DRAINAGE REPORT

LA VILLITA EAST COURT
ALBUQUERQUE, NEW MEXICO

Re Drainage report for La Villita East
Court

DRAINAGE REPORT FOR
LA VILLITA EAST COURT
ZONE ATLAS SHEET NO. H-23-Z

CHECK TO SEE IF BLADED CAMINO DEL LA SIERRA
 WILL CARRY THE WATER

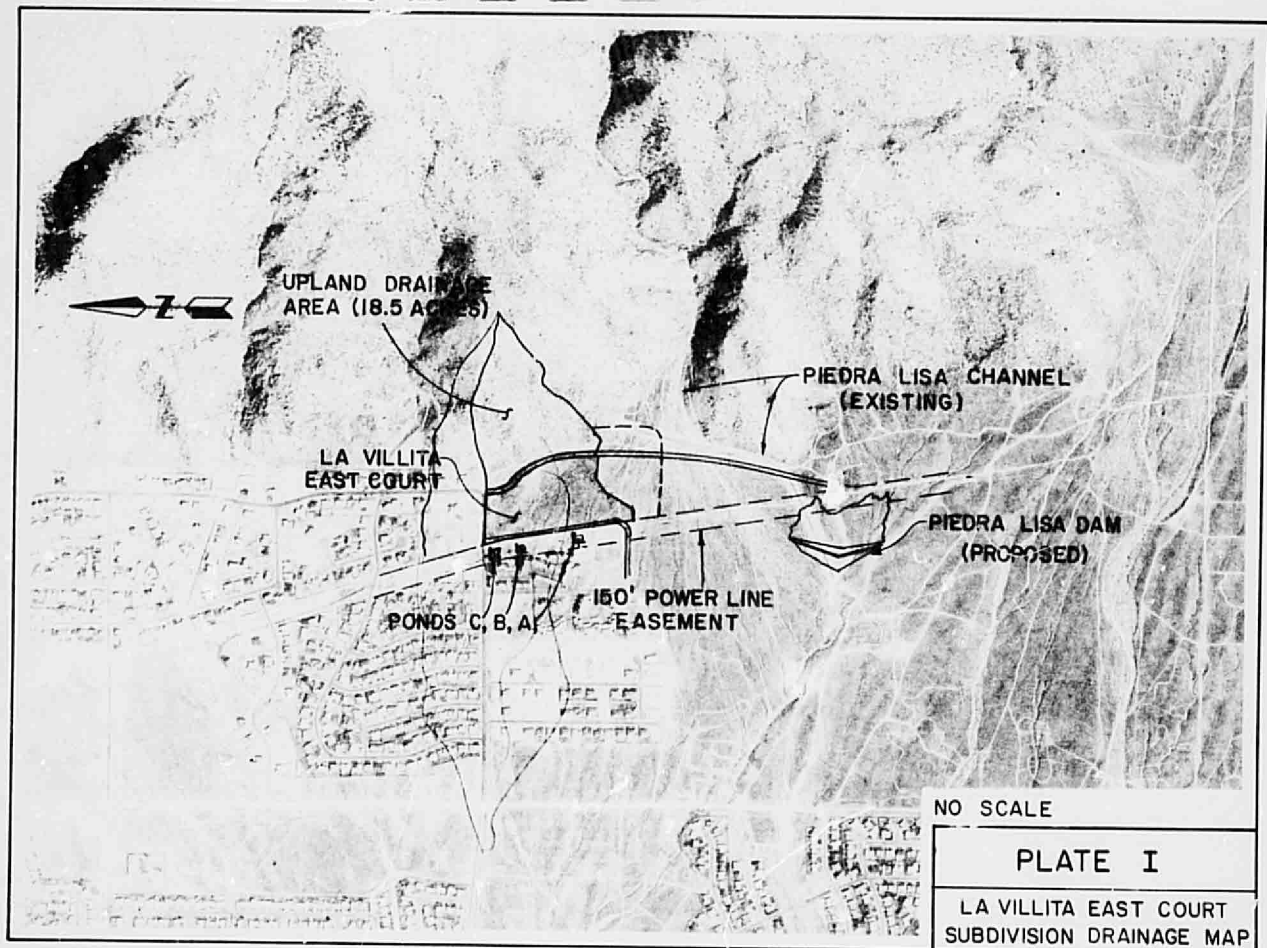
1. It appears Camino de la Sierra will need to be graded much more than one foot to carry the arroyo draining into area B to Candalaria. How will this be done and why shouldn't this area continue through the La Villita area? Section 31 of Subdivision Ordinance and Drainage Resolution should be read on this point.
2. Will the ponds block P.S. Co access ~~across~~ along the easement?
3. In area A & B what will keep flow from moving along the fence? If they do, what will happen?
4. No mention is made of the cattle guard type inlet shown on Plate VII.
5. Have you calculated flow depths and velocity in the streets and driveways? Can they be adequately handled?
6. If flows are diverted to Candalaria, how will infiltration, velocities and flows be affected?
7. What about a weed and debris rack for the pond inlets?
